54 Canal Street aka 9 Orchard Street

Amend the originally approved submission to include: restoration of domed spire to be GFRC & GFRP combination, increase approved roof deck height

(in compliance with ZR 74-711), modify approved balustrade design to incorporate code requirements regarding railing, add marquee at Orchard Street entrance, increasing dunnage height at roof

Historic Restoration and Preservation - Amendments

Jarmulowsky Bank Building Roof Deck - Balustrade

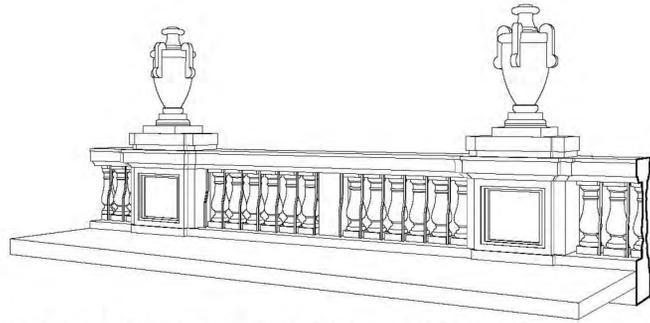
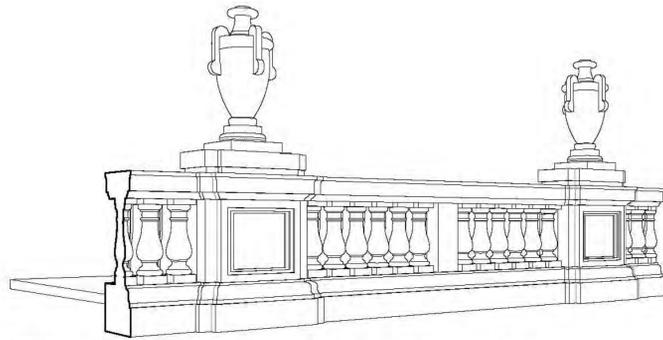
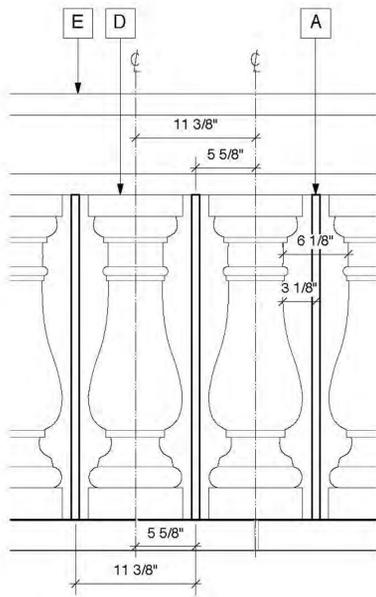
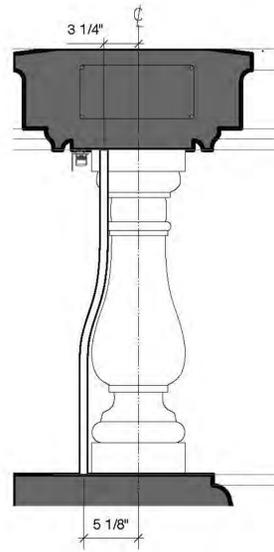
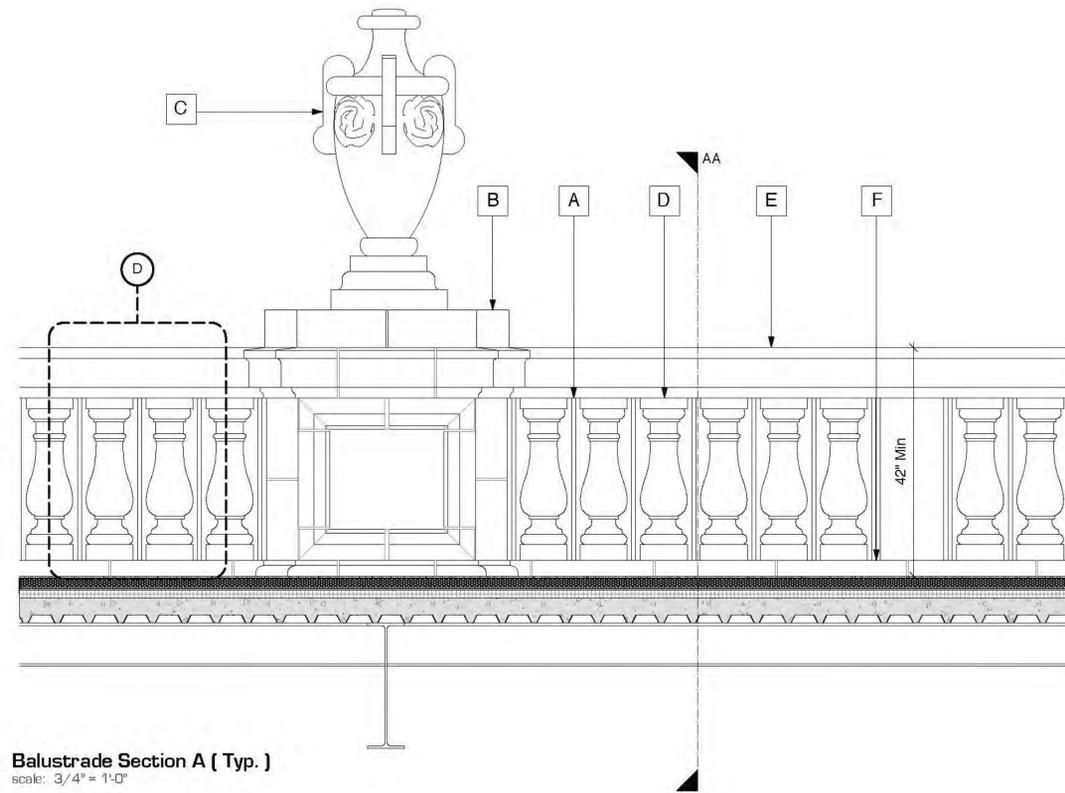
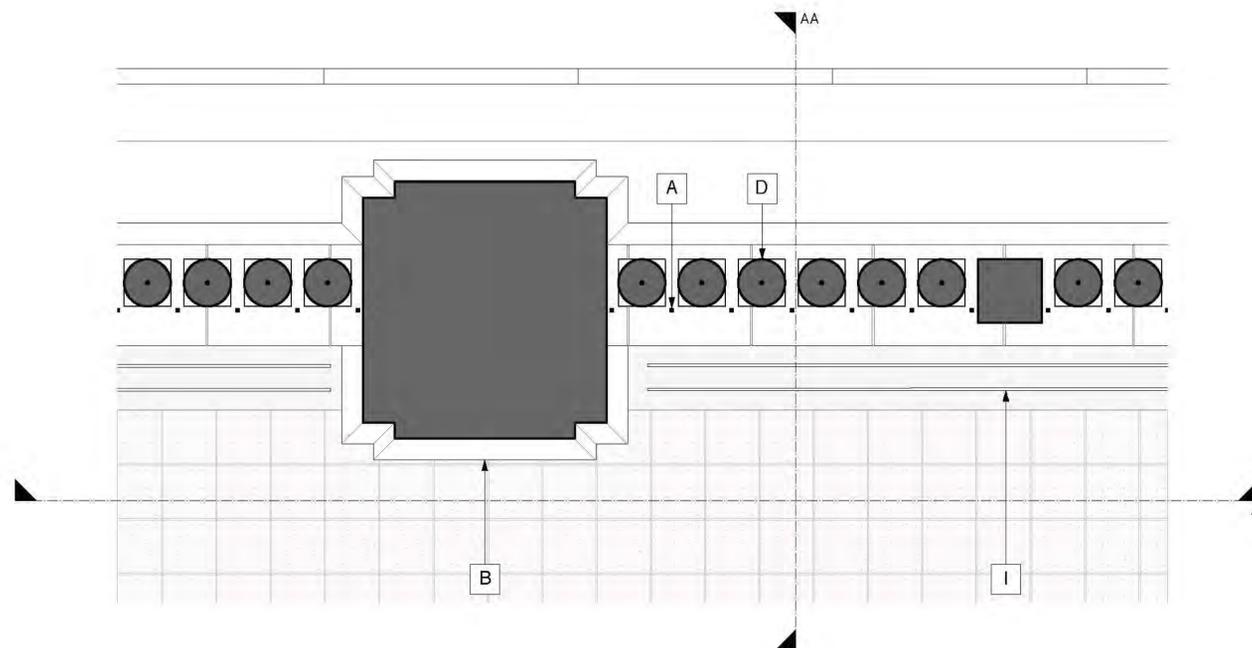
- A. Proposed metal rail to for compliance with NYC DOB 2008 Code
- B. Proposed Back Face of Pier to match front, GFRC
- C. Approved Urn, GFRC
- D. Approved Baluster, GFRC
- E. Approved Coping Stone, GFRC
- F. Approved roof deck proposed to be raised an additional 3'-1" Pursuant to the zoning text ZR 74-711
- G. Approved Cornice, GFRC
- H. Approved Lighting
- I. Proposed hidden water drainage. Drainage channels to be cut through approved cornice.

Jarmulowsky Bank Building Proposed Marquee Elevations & Section at Orchard Street

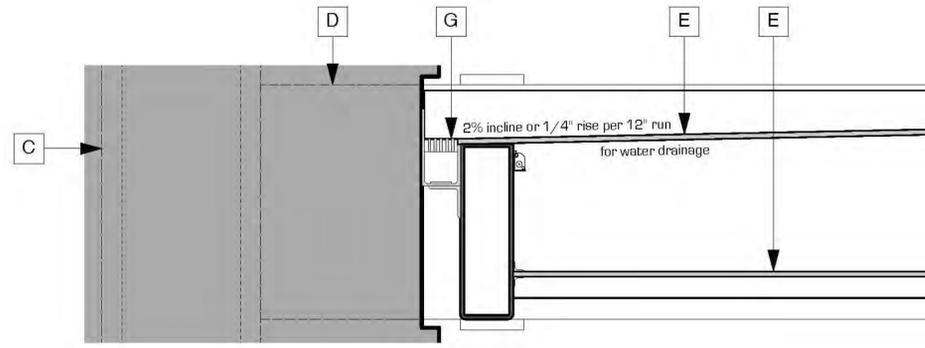
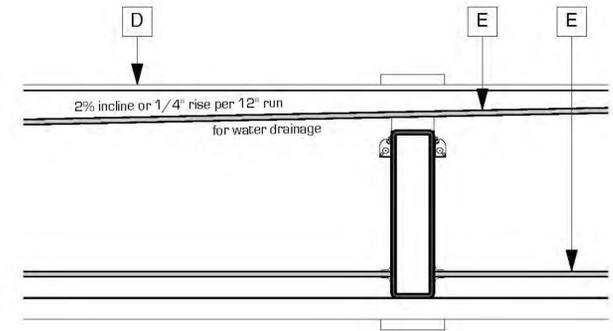
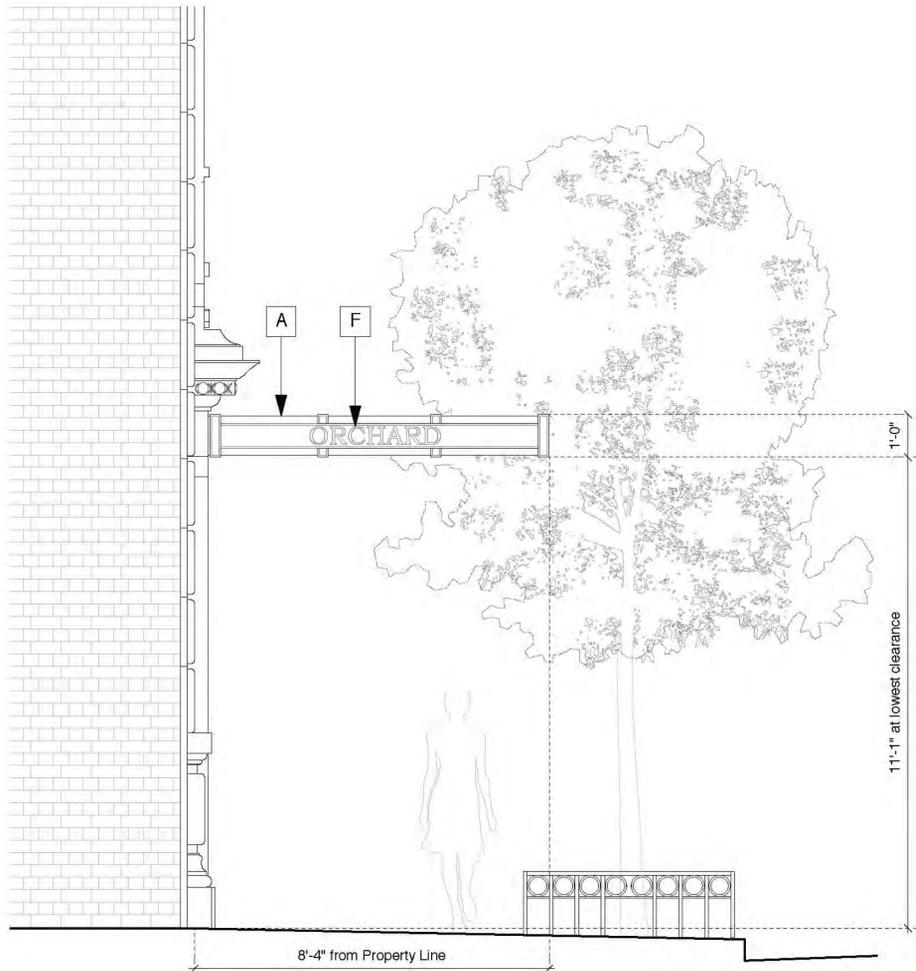
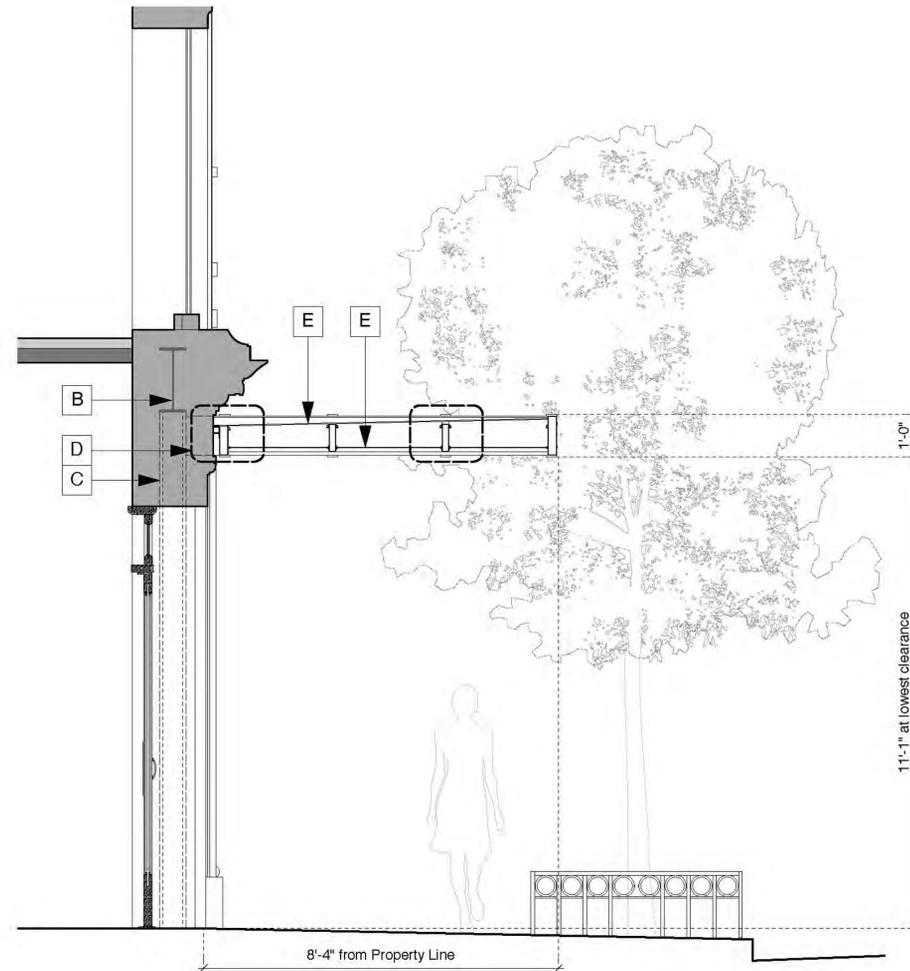
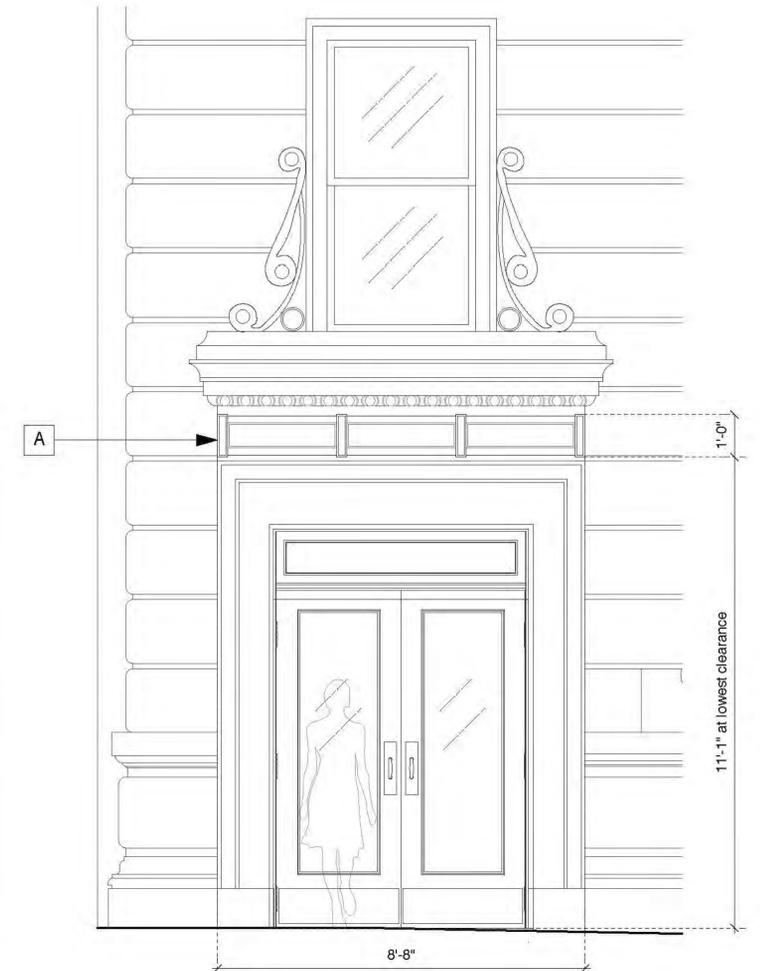
- A. Proposed Steel and Glass Marquee, 2% Incline for Drainage (Towards Building)
- B. Existing Steel Beam
- C. Proposed Steel Post between Existing Steel Beams at Floors 1 & 2
- D. Proposed Marquee Tube Steel Structure to be attached to proposed Steel Post
- E. Proposed Light Dispersion Glass Panel
- F. Proposed Building Signage - Content (Name) T.B.D.
- G. Proposed Gutter Drain between Façade and Marquee
